**45-DAY EXPRESS TERMS
FOR
PROPOSED BUILDING STANDARDS
OF THE
CALIFORNIA DEPARTMENT OF PUBLIC HEALTH**

**REGARDING PROPOSED CHANGES TO
CALIFORNIA CODE OF REGULATIONS, TITLE 24, PART 2
CHAPTER 31 B
PUBLIC SWIMMING POOLS**

FIGURE 31B-1
DEPTHS AND CLEARANCES FOR POOLS WITH DIVING BOARDS
GREATER THAN 30 INCHES (762 mm) ABOVE THE WATER LINE

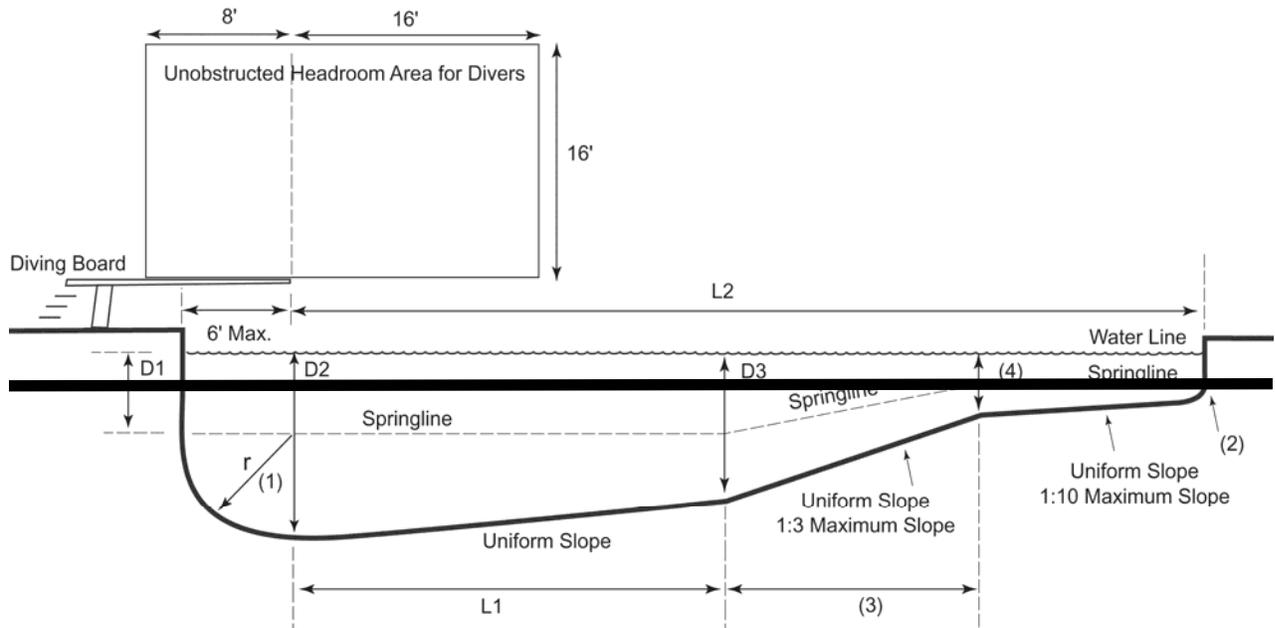
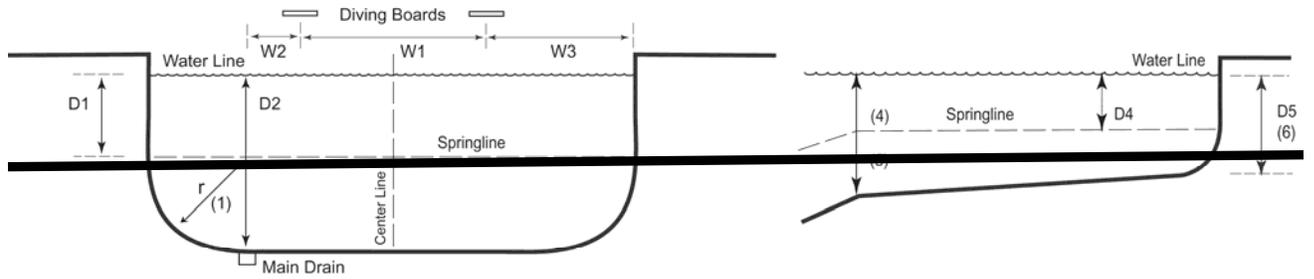
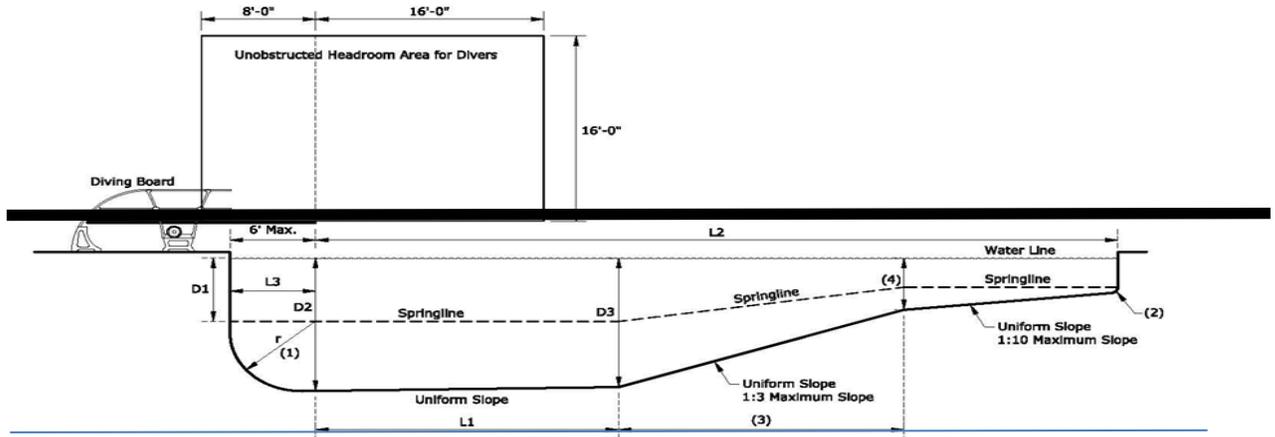
30) Amend Figure 31 B – 1 and Table 31 B -1 and Notes for Figure 31B-1 and Table 31B-1

1. Maximum radius shall equal D2 minus D1 dimensions.
2. Radius at the shallow end shall not be ~~not less than 6 inches~~ nor more than 12 inches.
3. The length of a section is based on the maximum slope and other maximum and minimum dimensions.

4. Where there is a break in slope, the break shall be located at a water depth equal to 4'6".
5. The springline depth at (4) shall not be ~~less than 2'6"~~ nor more than 4'0".
6. The maximum water depth shall be 3'6".
7. The main drain shall be located to provide complete drainage of the pool.

FIGURE 31B-2
DEPTHS AND CLEARANCES FOR POOLS WITH DIVING BOARDS
30 INCHES (762 mm) OR LESS ABOVE THE WATER LINE

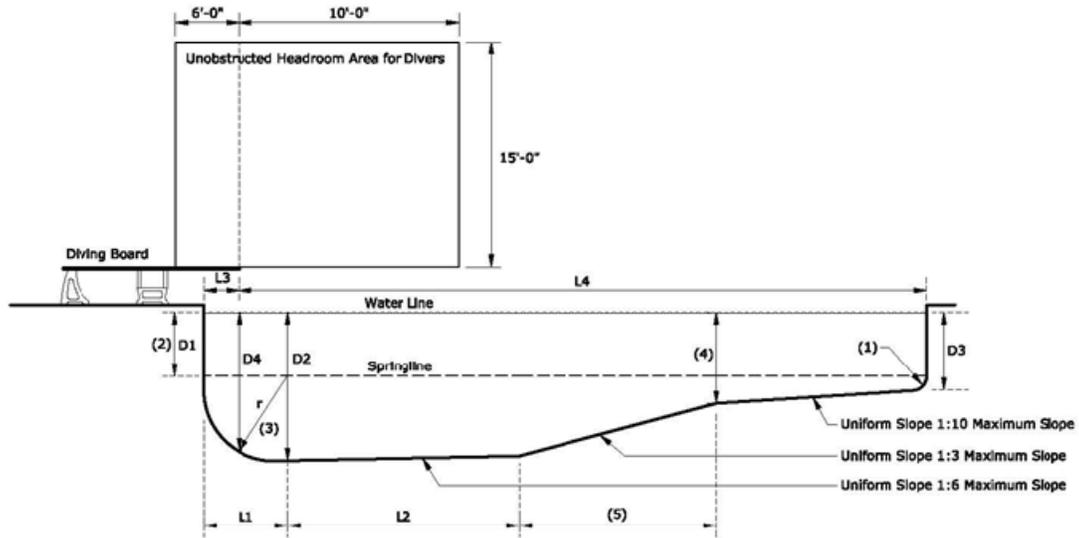
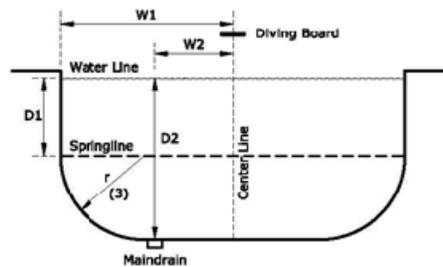
31) Amend Notes for Figure 31B-2 and Table 31B-2

1. Radius at the shallow end shall be a ~~minimum of 0'6"~~ and a maximum of 1'0".
2. Springline D1 shall extend to the break in slope between the shallow area and the deep area.
3. Maximum radius shall equal D2 minus D1 dimensions.
4. Where there is a break in slope, the ~~break in slope~~ shall be located at a water depth equal to 4'6".
5. Length of section is based on maximum slope and other maximum or minimum dimensions.
6. The main drain shall be located to provide complete drainage of the pool.

FIGURE 31B-3 DEPTHS AND CLEARANCES FOR POOLS WITHOUT DIVING BOARDS

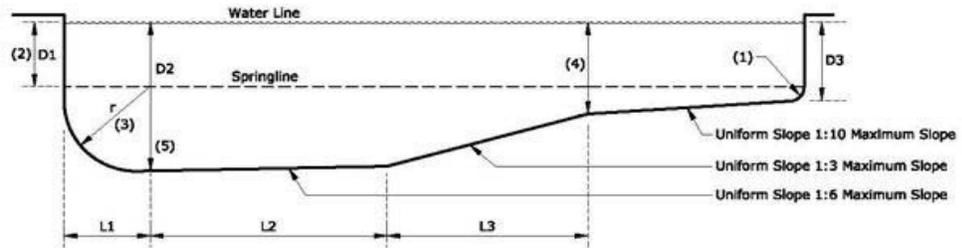
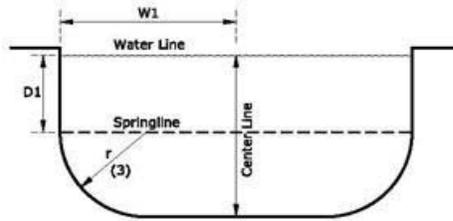
32) Amend Notes for Figure 31B-3 and Tables 31B-3a and 31B-3b

- 1. Radius at the shallow end shall be a ~~minimum of 0'-6"~~ and a maximum of 1'-0".*
- 2. Springline D1 shall extend to the break in slope between the shallow area and deep area.*
- 3. Maximum radius shall equal D2 minus D1 dimensions.*
- 4. Where there is a break in slope, the break ~~in slope~~ shall be located at a water depth equal to 4'-6".*
- 5. The main drain shall be located to provide complete drainage of the pool.*
